Repository Design and Thermal-Mechanical Effects

Presented to:
**NRC/DOE Technical Exchange
on Yucca Mountain Pre-Licensing Issues**

Presented by:
**Paul Harrington
Yucca Mountain Site Characterization Office
U. S. Department of Energy**

April 26, 2000

Shear Strength Curve Based on the Hoek and Brown Approach (GSI=62, σ_{ci} =167.9 MPa, m_i =19.68)

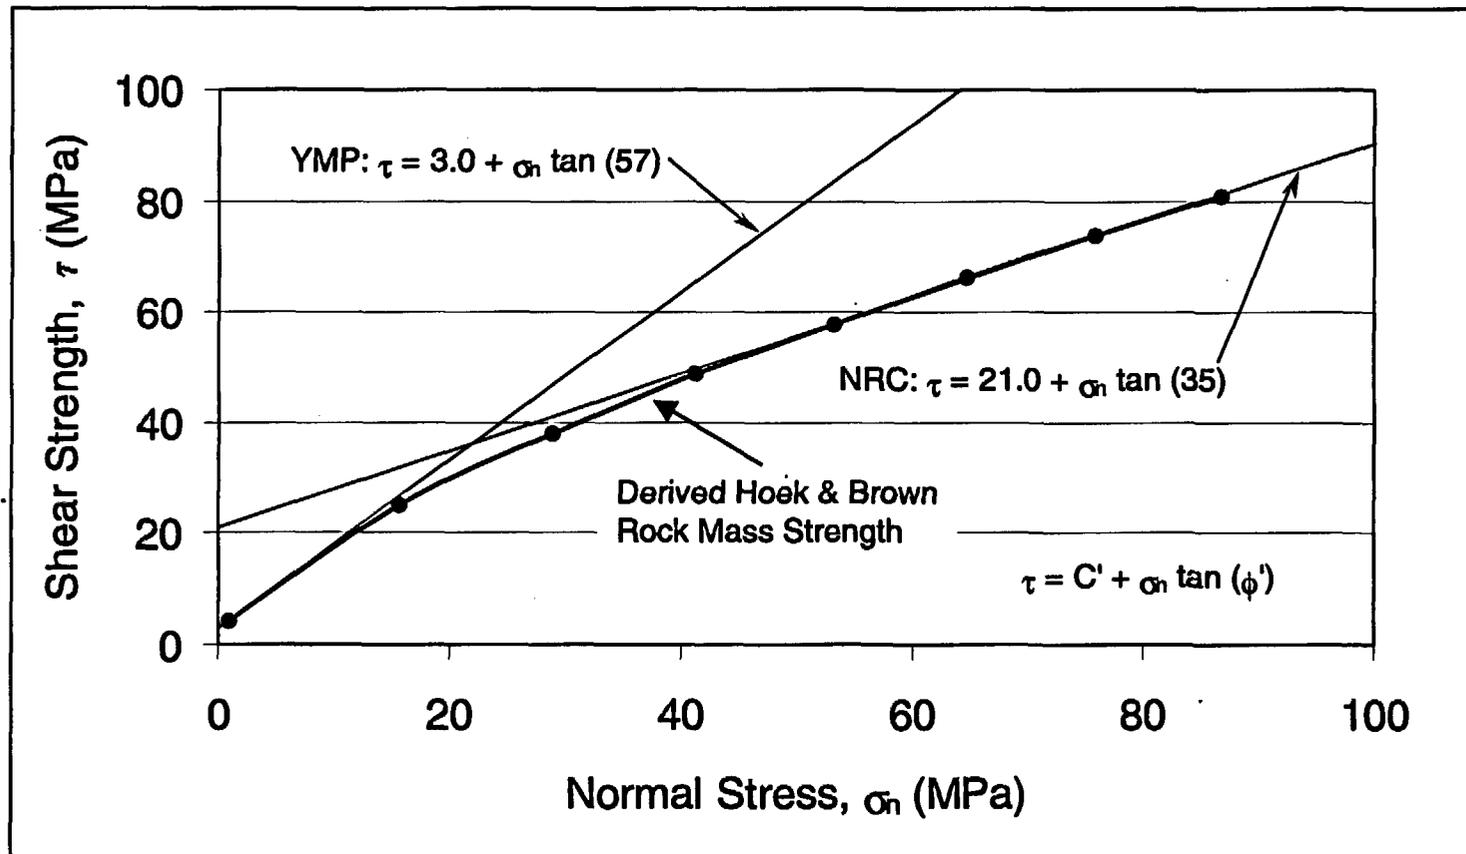
- Divergence of opinion related to predicted rock mass friction angles (IRSR, Section 4.3.3.2)
- DOE estimated rock mass properties based on geotechnical mapping of the rock mass following guidelines described by Hoek and Brown
- IRSR reports discrepancy in rock mass friction angles
 - DOE values: 57° to 58°
 - NRC values: 28° to 35°

- DOE/NRC basic approach to assessing rock mass friction angle is the same. The difference is in the stress range over which the friction angles were calculated
- DOE letter to NRC of 3/00 addresses in detail

Cumulative Size Key Block Distributions for Tptpl Unit (Seismic Case, Current Emplacement Drift Alignment)

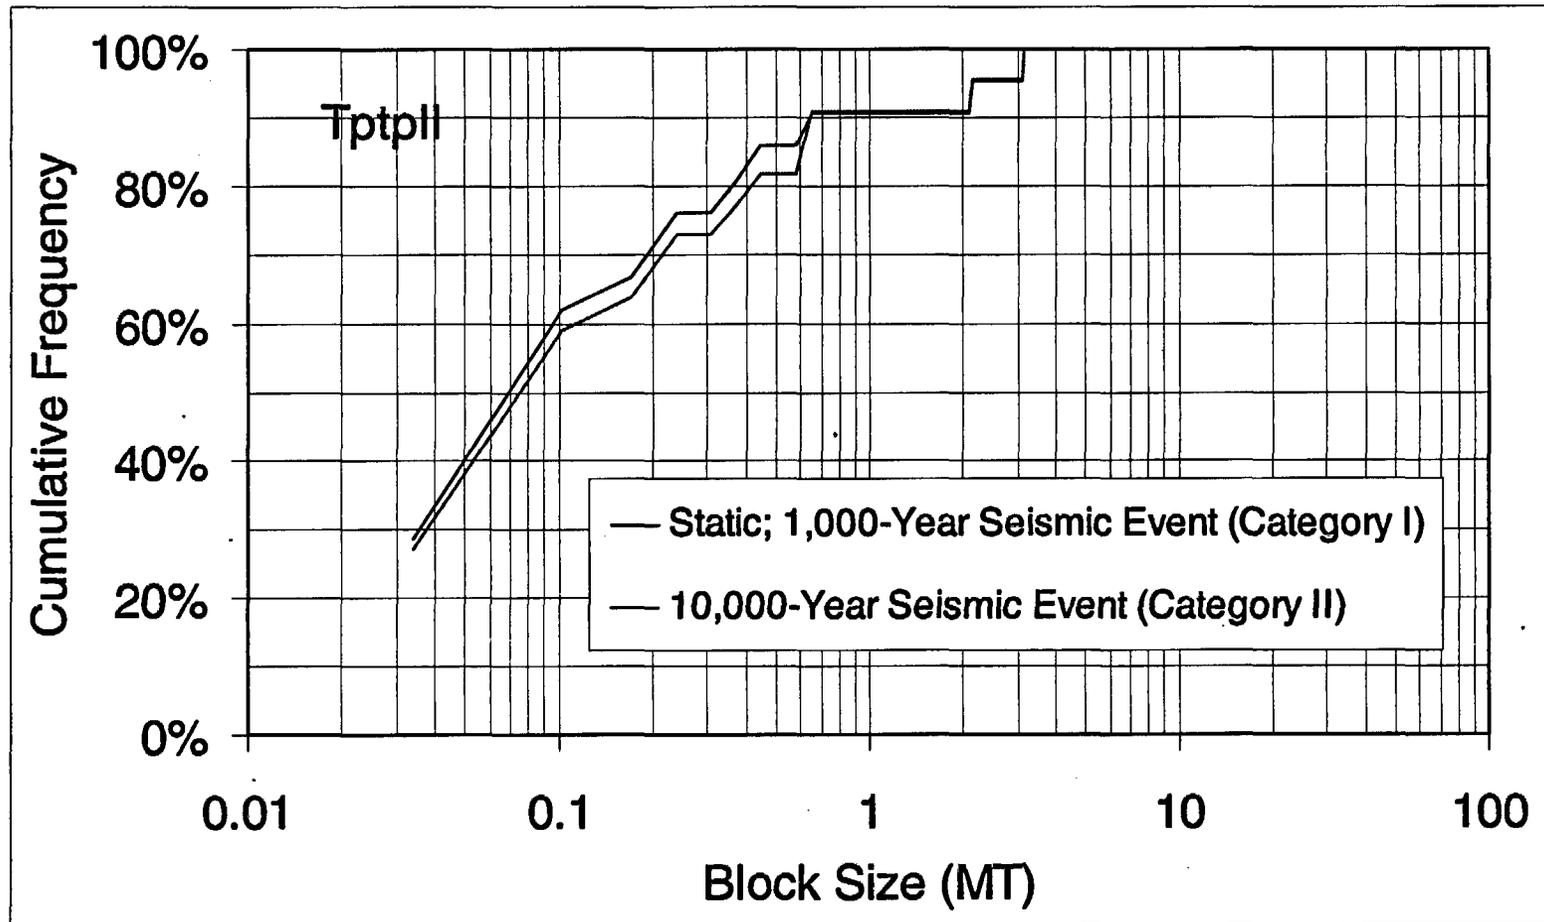
- At Appendix 7 meeting in November 1999, NRC staff expressed concern related to a need for additional dynamic analyses to validate the existing approach
- Current drift degradation analysis
 - Based on VA emplacement drift alignment
 - Includes backfill
- New calculation (March 2000 - in review) includes revised block sizes based on new emplacement drift alignment and excludes backfill

- **Planning under development for revised drift degradation analysis**
 - Will include current emplacement drift alignment and exclude backfill
 - Will consider additional dynamic analyses for seismic effects on rockfall
